PCI-SIG ENGINEERING CHANGE NOTICE

TITLE:	M.2 COEX Signal Definition - UART
DATE:	October 19, 2014
AFFECTED DOCUMENT:	M.2 Spec Revision 1.0
SPONSOR:	Ra'anan Sover; Intel Corp

Figure 87. Type 2226 SDIO Based Module-Side Pin-Out

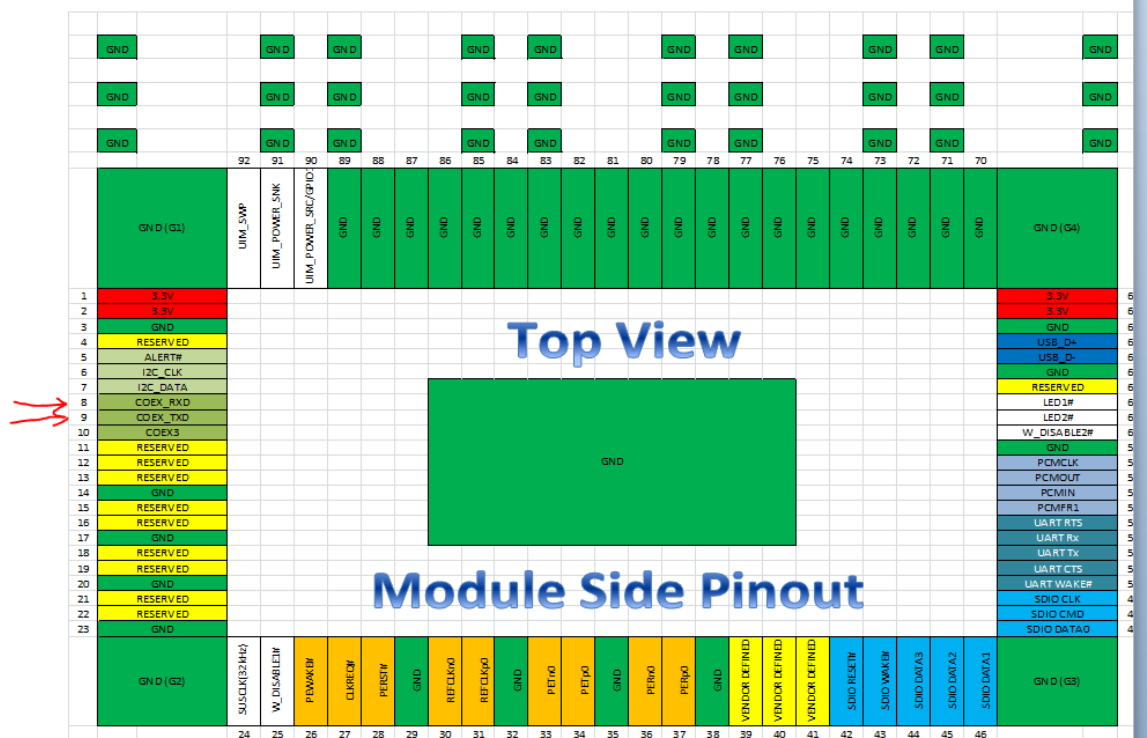
Change Diagram 87 as follows:

Figure 93. Type 1216 LGA P Out on Platform

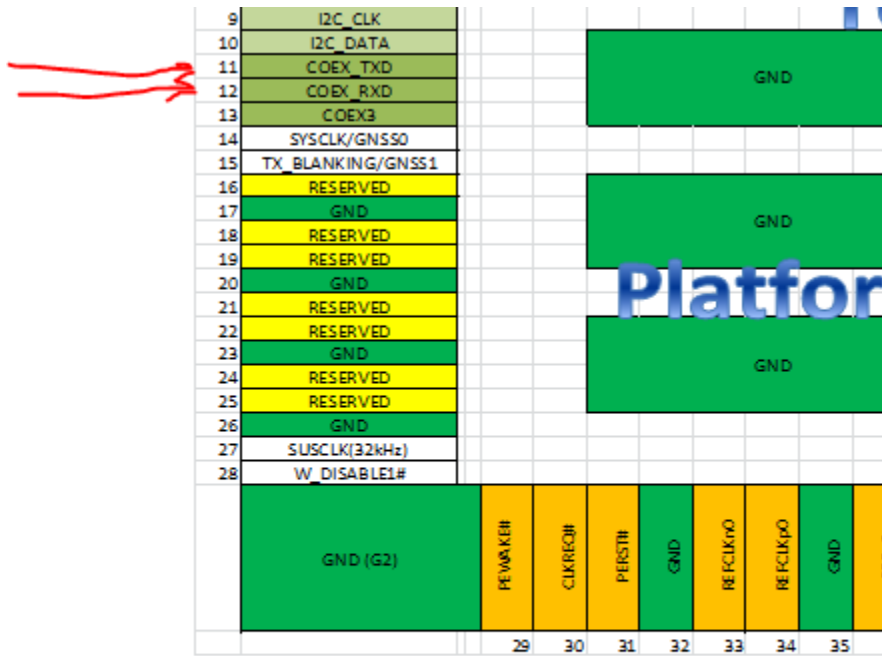
Change Table 47 as follows:

Figure 94. Type 3026 LGA Pin-Based Pin-Out on Platform

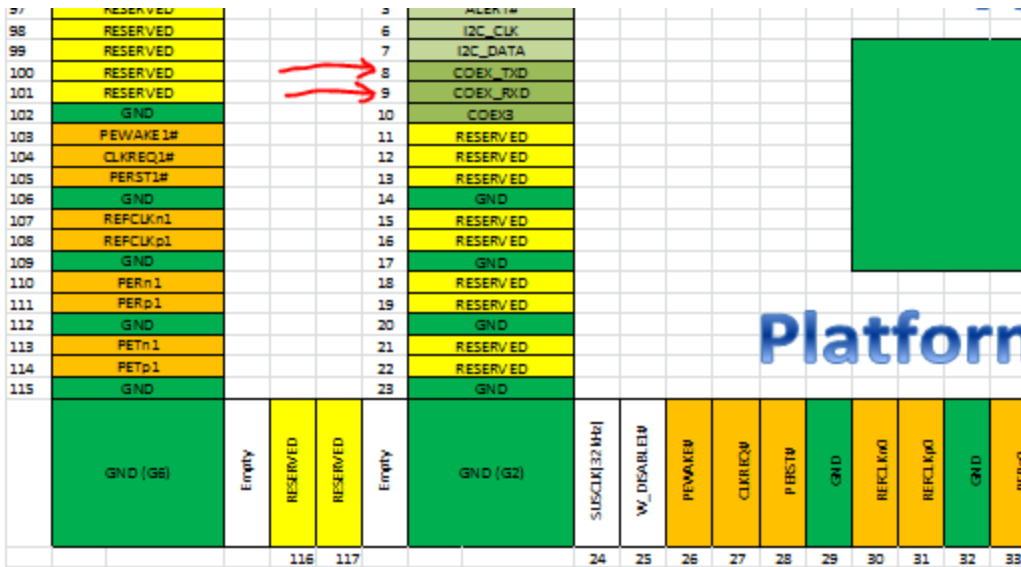
Change Figure 94 as follows:

Figure 97. COEX_TXD and COEX_RDX Signal Directions

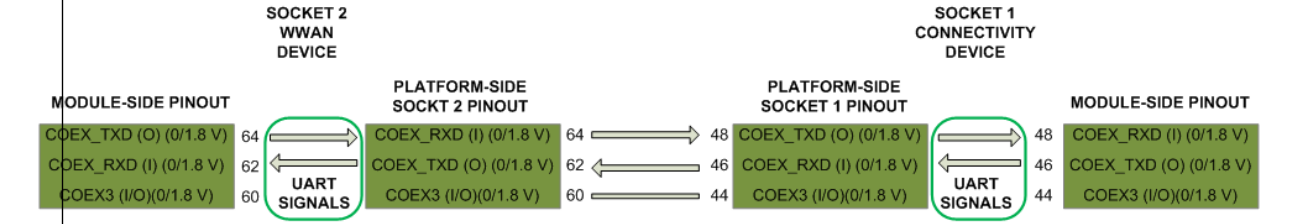
Addition of Figure 97 to show COEX UART signal directions as follows:

The two COEX signals between the WWAN device on Socket 2 and the Connectivity device on Socket 1 have defined directions and shown in Figure 97. At the platform, the three COEX signals should be connected pin to pin as shown in Figure 97.
